Client:	Clockstrike Ltd.
Project Title:	Proposed Residential Development (Phase 01)
Project Location:	Ringwood, Blarney, Cork
Document Title:	Surface Water Drainage Technical Note-RFI Response –
Document No.:	21079HD-MHL-TN00-DRA-Rev B_Surface Water Drainage Technical Note-
Author/s:	Mr. David Murphy, MHL & Associates Ltd.
Job No.:	Surface Water Drainage Technical Note-RFI Response –
Date:	07/10/2024

MHL & Associates Ltd (MHL) have been appointed by the Clockstrike Ltd. to prepare a **Surface Water Drainage Technical Note-RFI Response** for an LRD Application in Ringwood, Blarney, Cork. This technical note sets out our responses to Cork City Council’s request for further information on Drainage queries at the Proposed Residential Development (Phase 01) at the Ringwood site, in particular the following:

Figure 3.1 – Preplanning site context

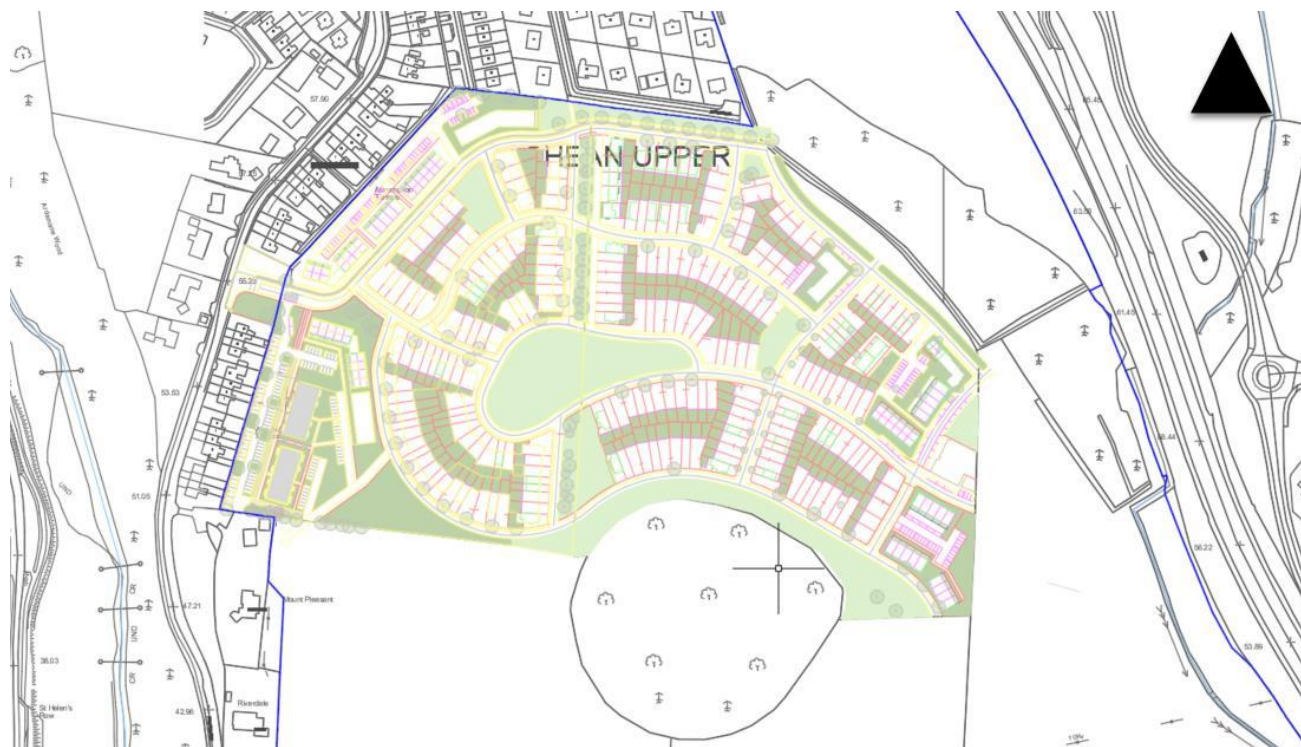
- Please clarify why the number of attenuation tanks has increased.
- Please clarify if the drainage strategy for Phase 01 takes account or makes allowances for Phase 02.

The design submitted at planning opinion stage included for 3Nr. attenuation tanks as part of the pre planning Phase 01 design. This design was reflective of the early data acquisition on site, i.e. site investigation, the provisional residential layout and provisional FFL and corresponding road design levels. Subsequently, the drainage design information at the pre planning stage was reflective of the site layout (Figure 3.1) proposed at that stage.

Figure 6.1 Proposed maintenance vehicle / tank access.

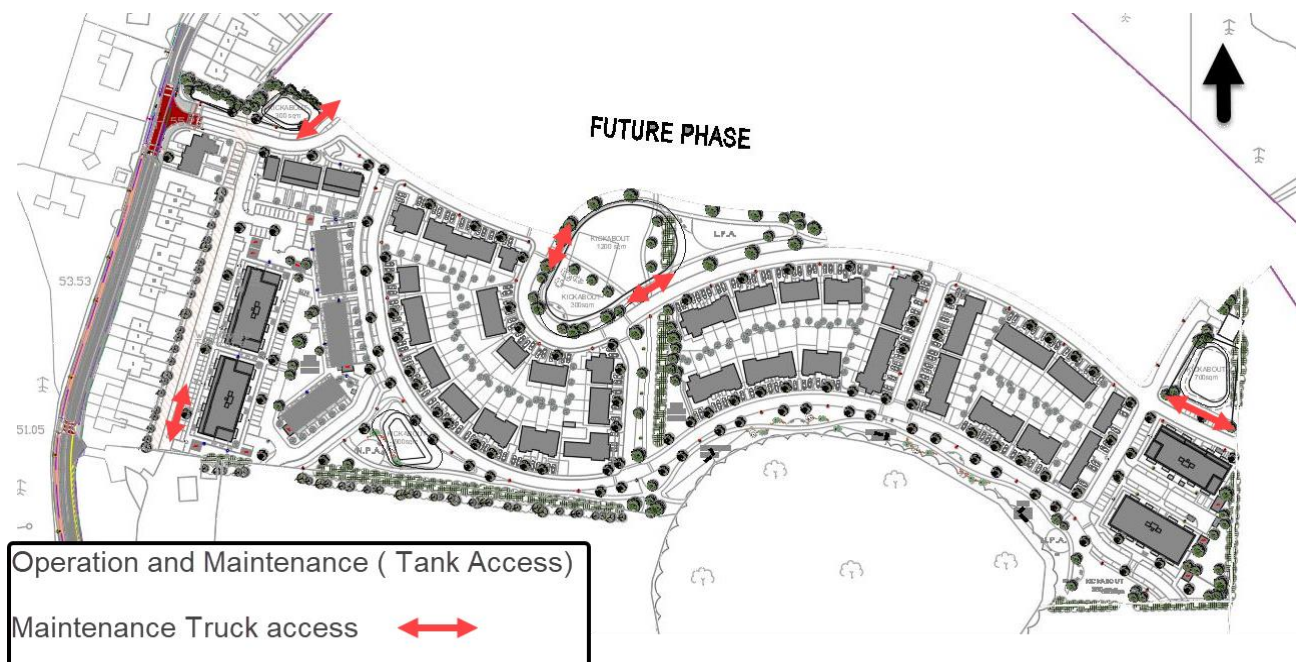
The Drainage LRD Opinion Report raised concerns over access to the proposed attenuation tanks during operation and maintenance. The applicant was requested to clarify how the tanks will be accessed and maintained safely which was not addressed in this application. Please clarify how each of the 4Nr. proposed attenuation tanks will be accessed and maintained safely. This should include highlighting where plant and machinery can be parked and located safely during maintenance works. It should be noted that it is the duty of designers to ensure a project can be constructed and maintained safely. This includes the identification, and elimination or mitigation of risks during the operation and maintenance phase.

In response to the request for clarification on how the four proposed attenuation tanks will be accessed and maintained safely, each of the 4 attenuation tanks are designed with practical access points to facilitate routine inspection and maintenance activities. The design incorporates safety measures to ensure that maintenance personnel can perform their tasks without risk to their health and safety.

Each tank will be equipped with dedicated access hatches, compliant with safety regulations, allowing for easy and safe entry during maintenance operations. The access points will be marked, and their locations are to ensure minimal disruption to surrounding areas during maintenance.

Figure 7.1 Phase 01- Suds basin/ attenuation tank design

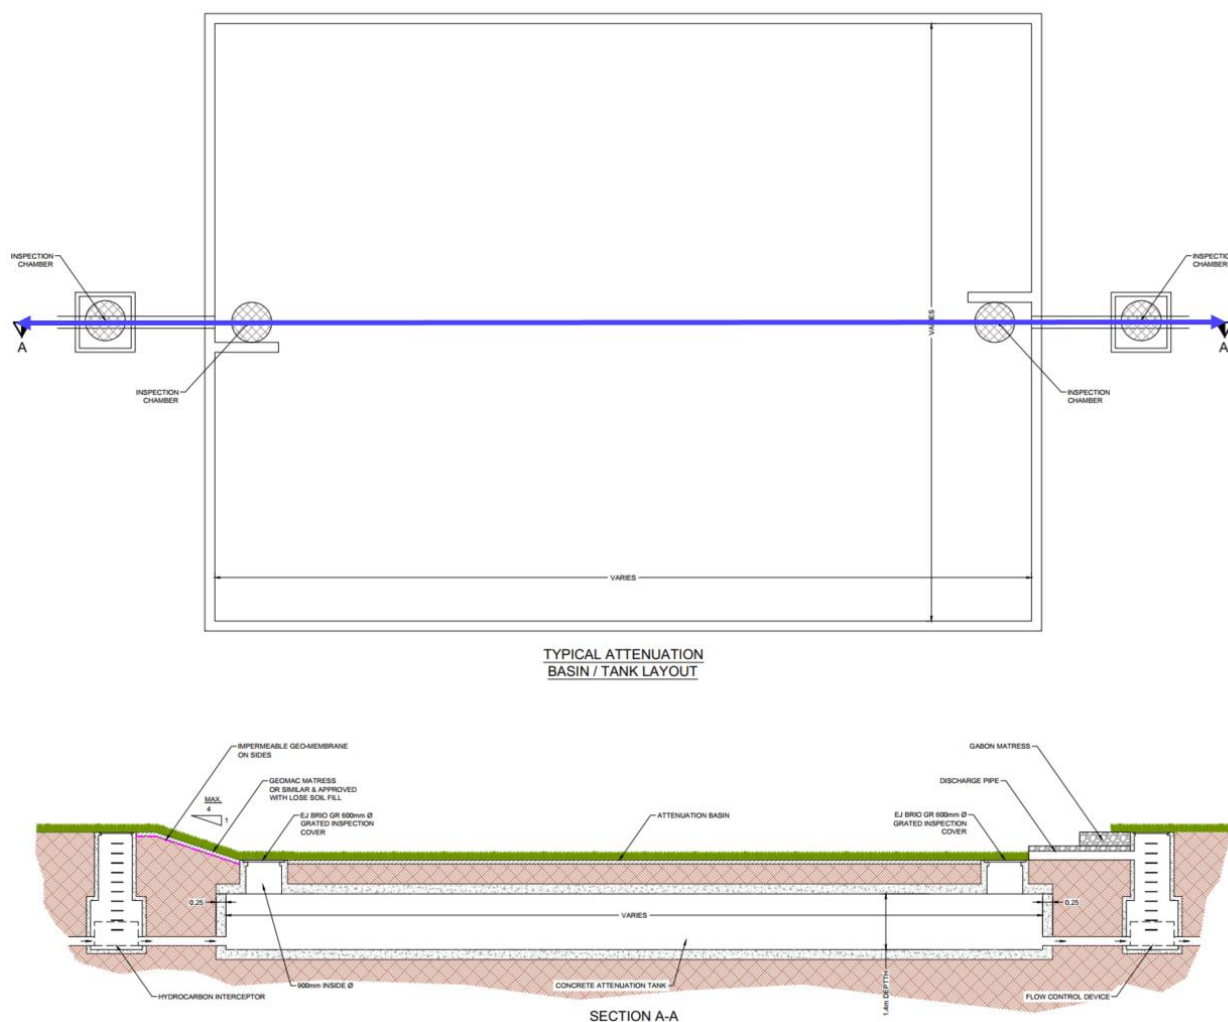
- Please detail how the proposed detention basins will function and if they are interconnected with the attenuation tanks.
- Please provide full details, layout drawings, cross sections and storage volume calculations for each of the proposed detention basins.
- Please clarify how long the detention basins will be wet or hold water following arrange of storm events from 50% AEP up to the 1% AEP
- Please clarify the side slopes and maximum depth of water in each of the detention basins and if there are any overflow controls
- Please clarify the level of the water table and any risk of floatation for each of the attenuation.

On the recommendations for the LRD opinion stage, the pre planning design was adjusted to incorporate SUDS measures were noted in the formal LRD application. This application includes 4No. detention basins, with 3No. of the proposed detention basins located on top of the proposed attenuation tanks (i.e. 1a, 1c, 1d)

The design of the reinforced concrete (RC) tanks and Sustainable Urban Drainage System (SUDS) basins manage stormwater runoff from the new residential development. The RC tank provides underground attenuation storage, collecting stormwater during peak rainfall events and controlling the discharge rates to prevent overwhelming the local drainage network. The SUDS basin complements this by providing additional surface-level storage and promoting the natural infiltration of water into the ground. Both systems are connected by inspection chambers, ensuring a regulated discharge that aligns with the site's drainage strategy, reducing the risk of flooding, and accommodating the increased storm flow rates generated by the development.

The proposed detention basins are to provide additional storage duration peak storm events and also act as a conduit for storm surface flows running of hardstanding areas and within the green park areas. The basins are to be interconnected with the attenuation tanks, as referenced in 21079HD-MHL-DBATD-P01 and Figure 7.1 below.
